**GENOA CHARTER TOWNSHIP
PLANNING COMMISSION PUBLIC HEARING
SEPTEMBER 10, 2018
6:30 P.M.
AGENDA**

Attention:	Kelly Van Marter, AICP Planning Director and Assistant Township Manager
Subject:	Dog Town/Kitty City – Special Land Use and Site Plan Review #2
Location:	3557 East Grand River Avenue – north side of Grand River, east of intersection with Grand Oaks Drive
Zoning:	GCD General Commercial District

**Re: Dog Town and Kitty City, LLC
Site Plan Review**

Attention:	Kelly Van Marter, AICP Planning Director and Assistant Township Manager
Subject:	Volunteers of America –Sketch Plan Review #1
Location:	2700 E. Grand River Avenue – south side of E. Grand River, east of Chilson Road
Zoning:	GCD General Commercial District

EXISTING CONDITIONS & DEMOLITION PLAN

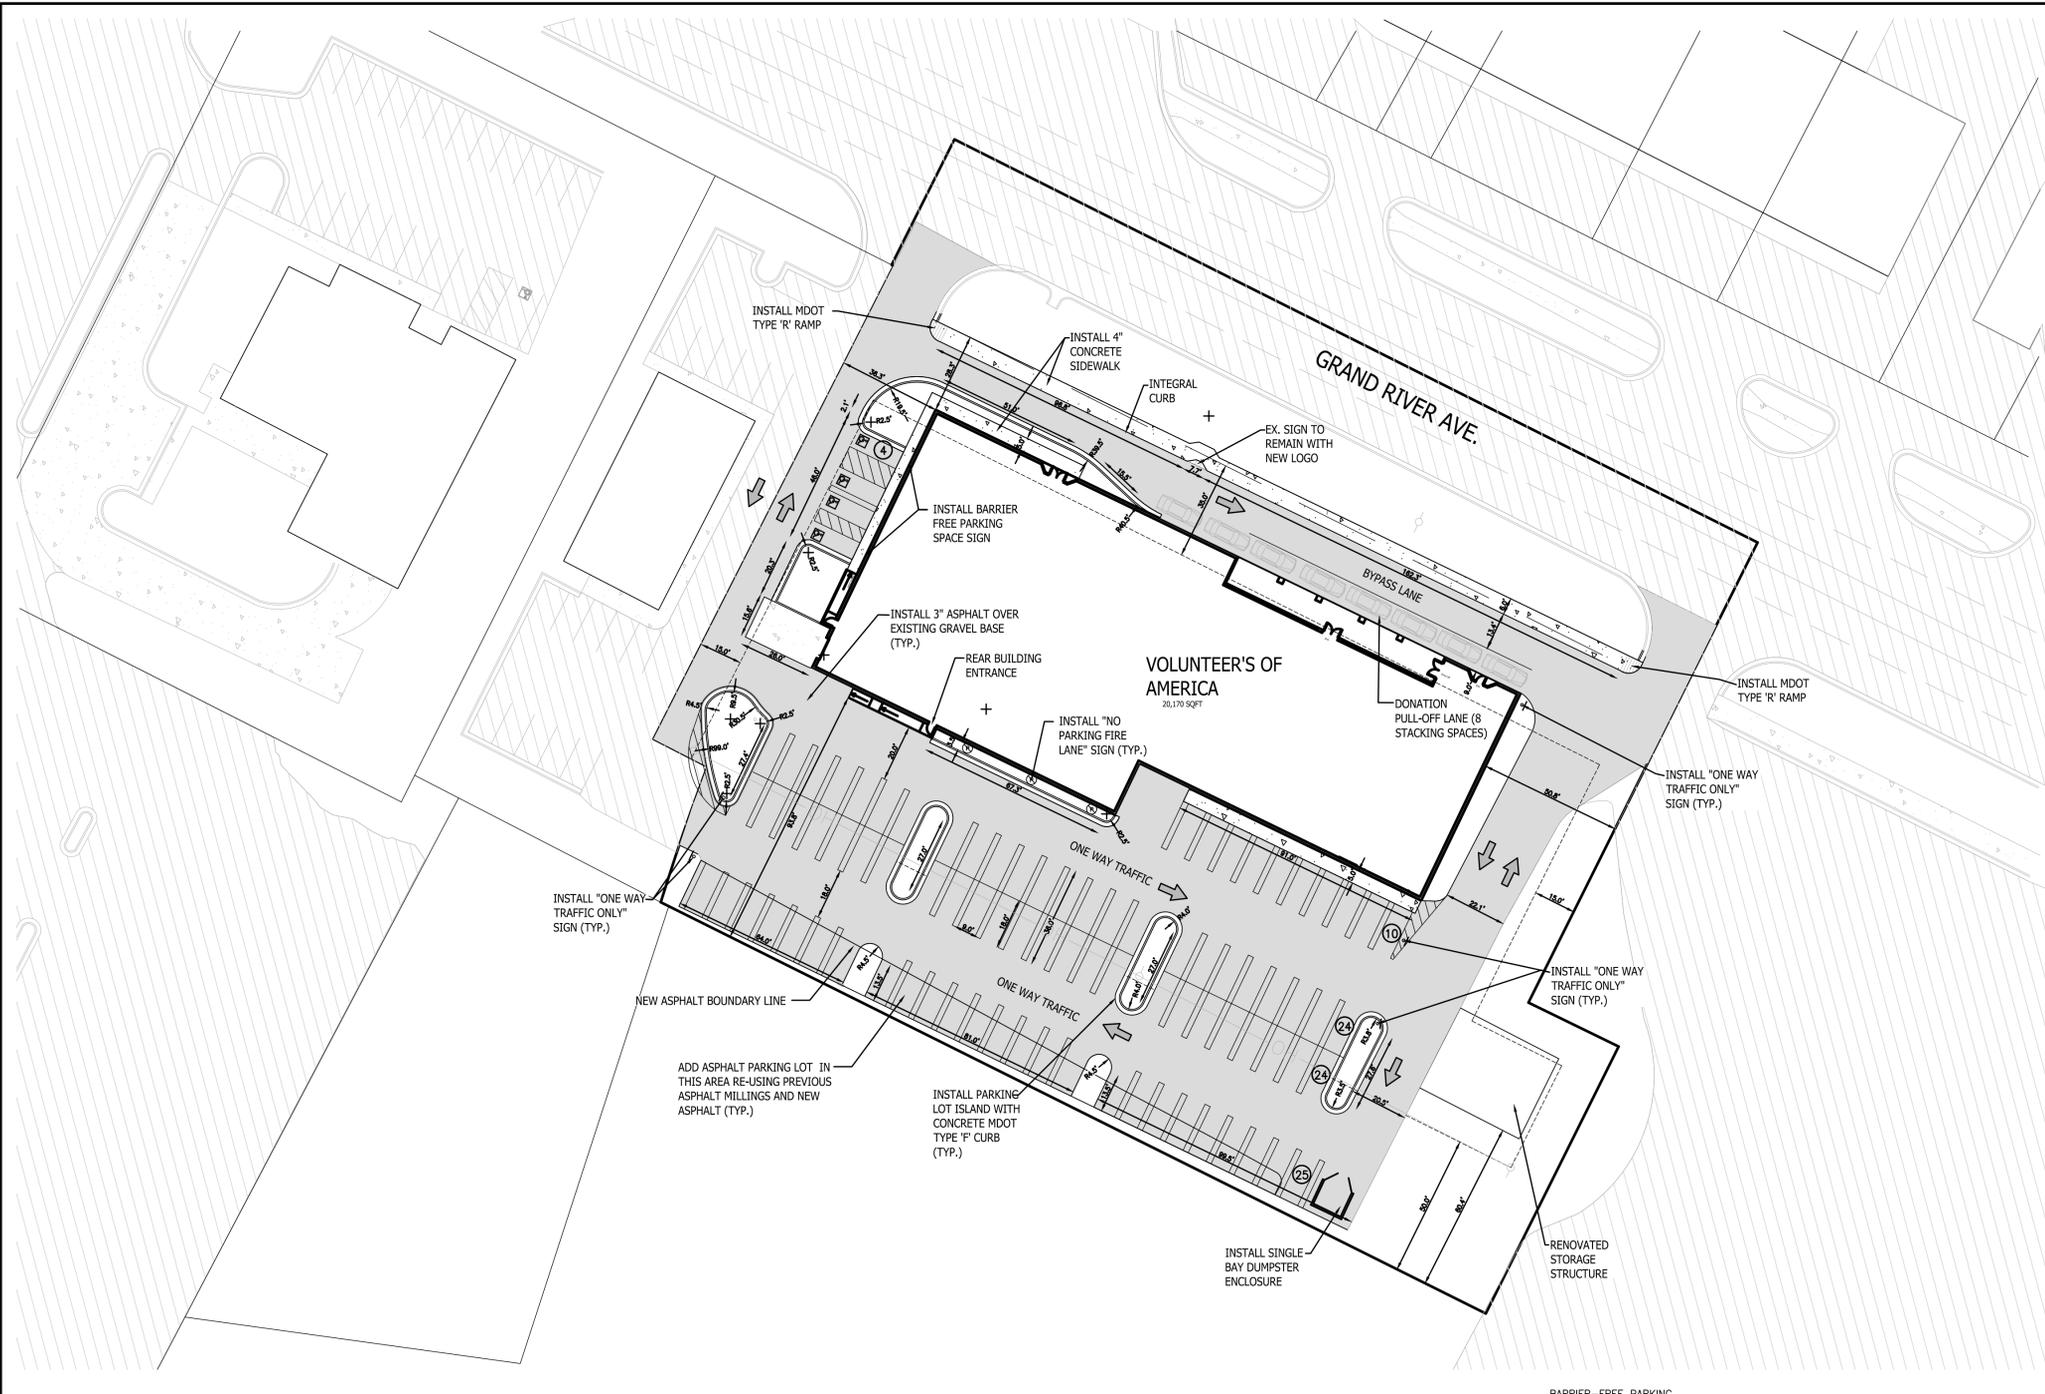
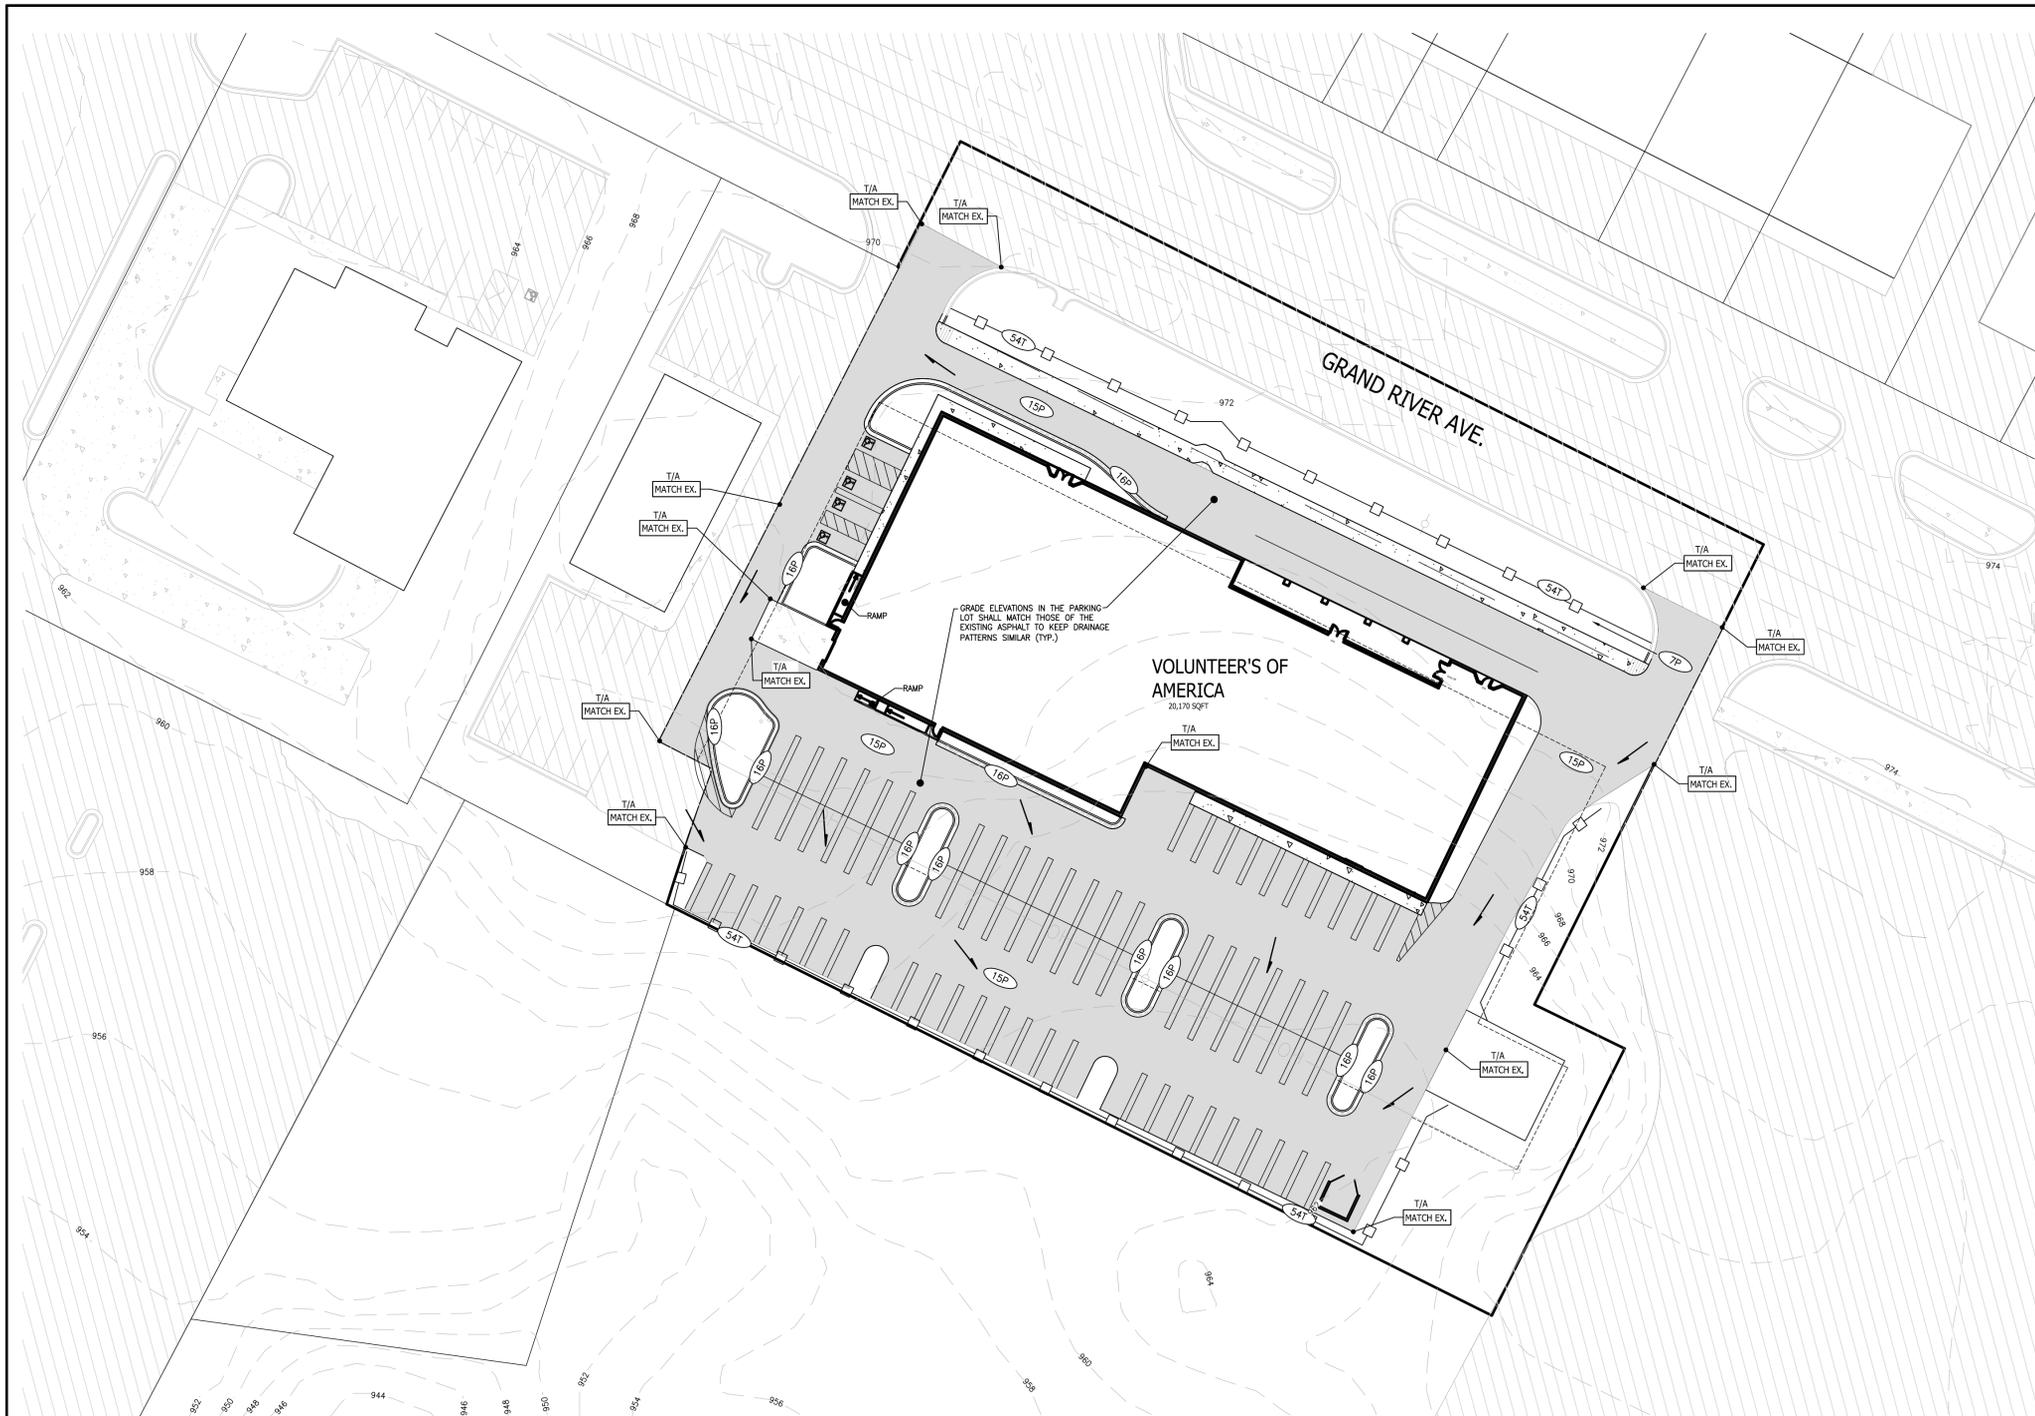
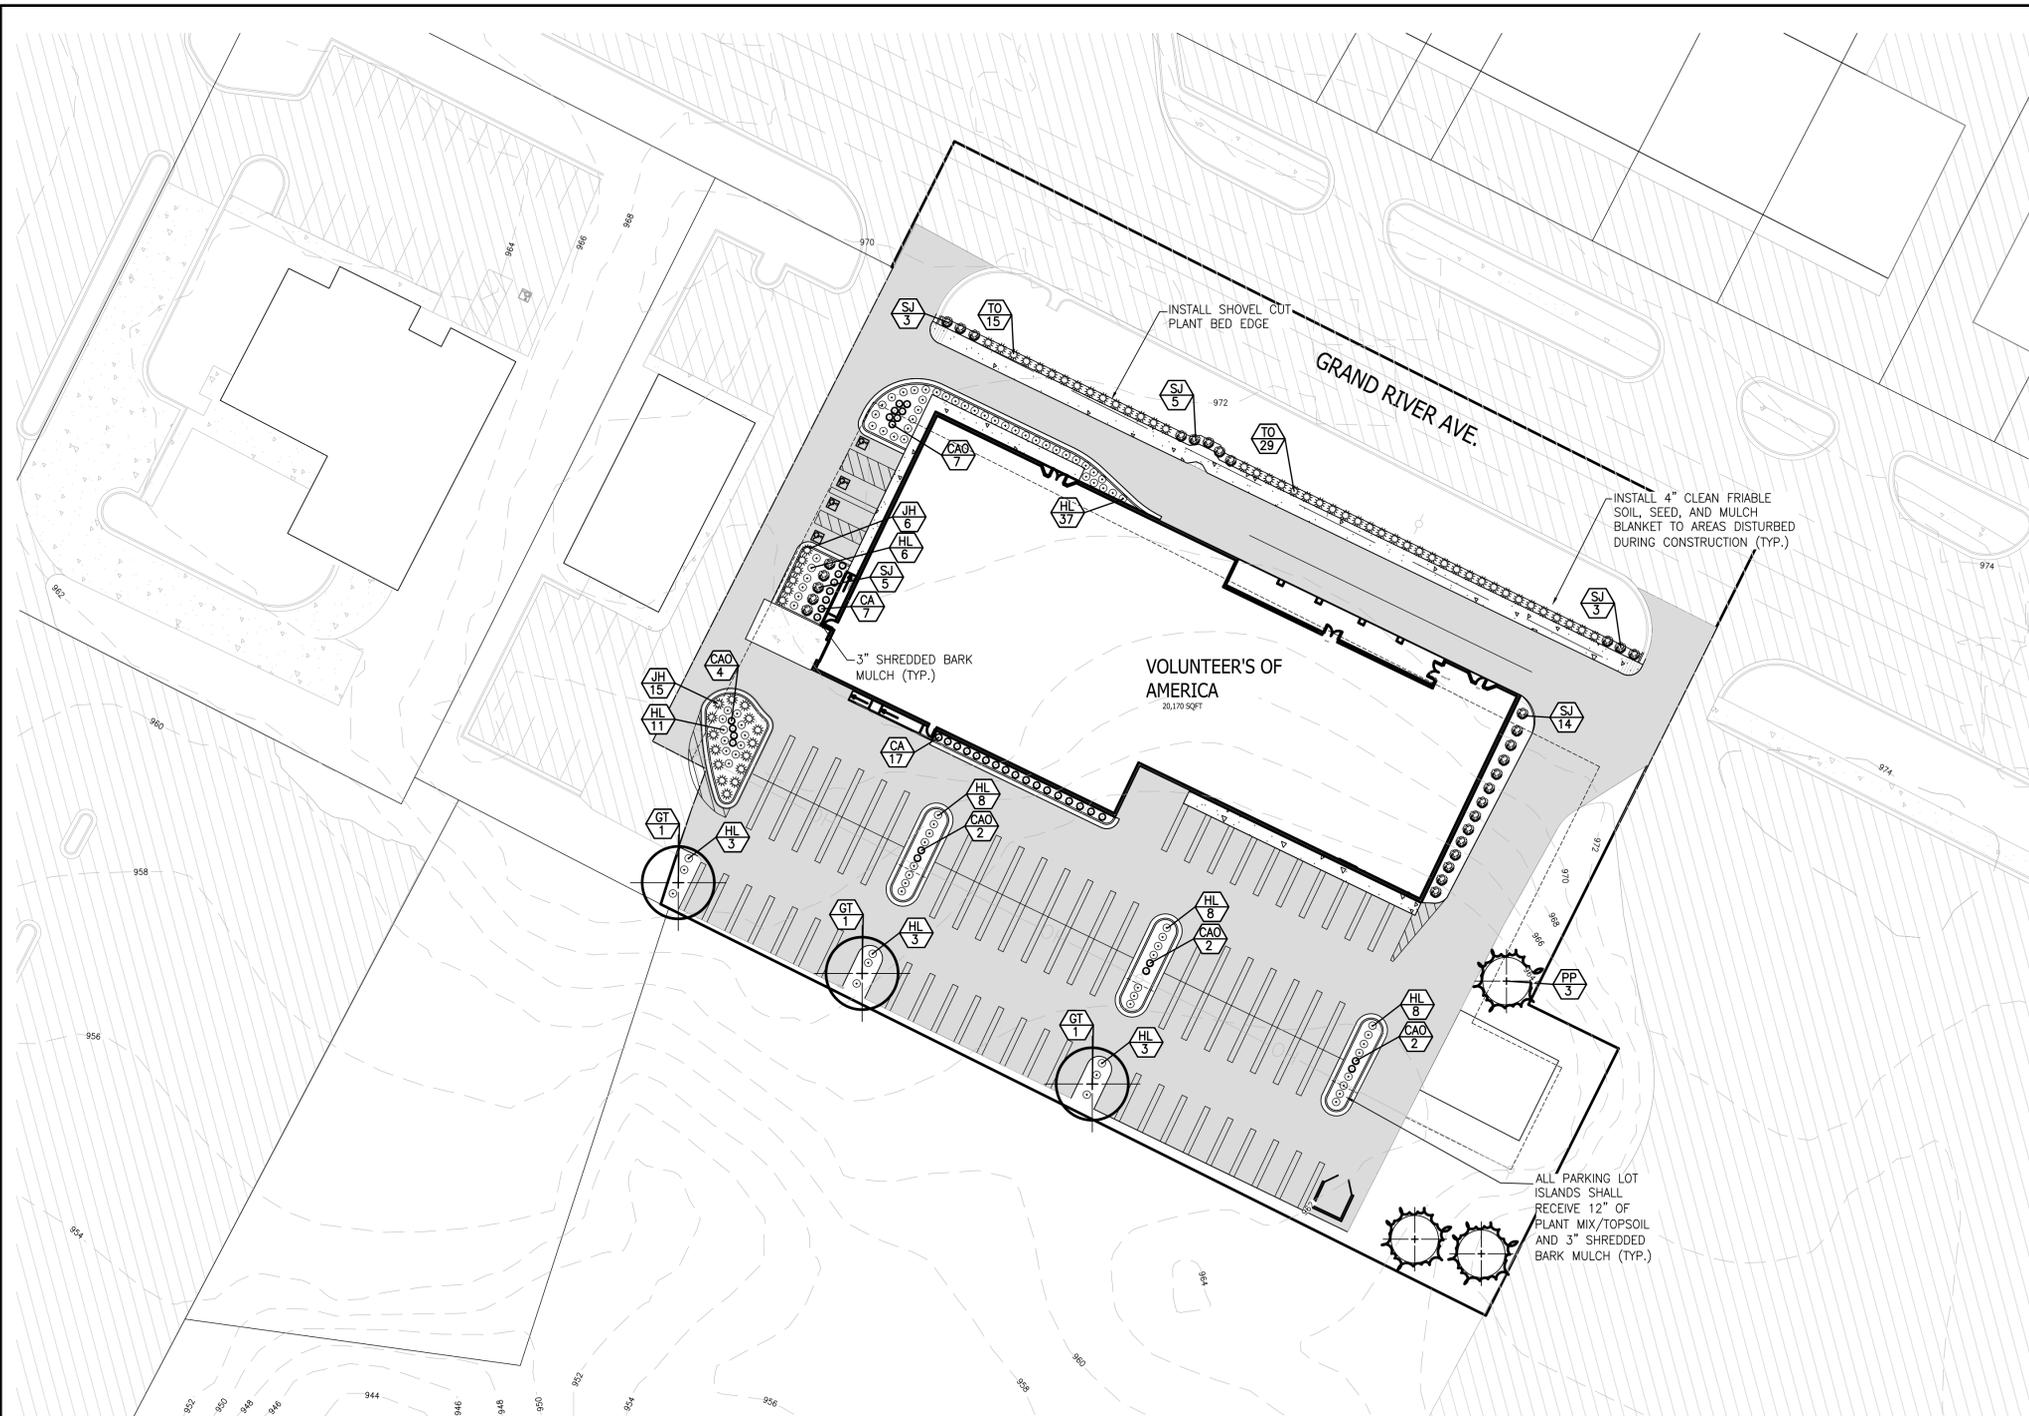
7. We suggest additional plantings be provided in the southeast corner of the site.
8. The proposed wall mounted light fixtures (shine outward with a visible light source) do not meet Ordinance standards (downward directed and cut-off).

- 1. Dimensional Requirements.** The only dimensional standard impacted by the proposal is a new row of parking along the rear lot line, which does not provide the required setback (10'). However, Section 14.06.11 allows the Commission to reduce or waive this requirement given the presence of a shared access driveway.
- 2. Building Materials and Design.** The primary materials on the existing building are CMU and EIFS. The elevation drawings provided (Sheet A2) note the only changes as repair and painting of the existing building, as well as the installation of new canopies above the windows.

- The sketch plan does not include the existing utilities. The petitioner should include the existing water main, sanitary sewer lead and existing well on the final plans. The connection to the existing well should be confirmed. If the connection exists, the building should be disconnected from the well and connected to the existing water main on the north side of the property. The well should be abandoned as part of the site improvements.

- Curb and drainage structures should be included around the parking lot perimeter to control stormwater and vehicle access to the site. Placement of drainage structures shall be dependent on the response from the LCDC.
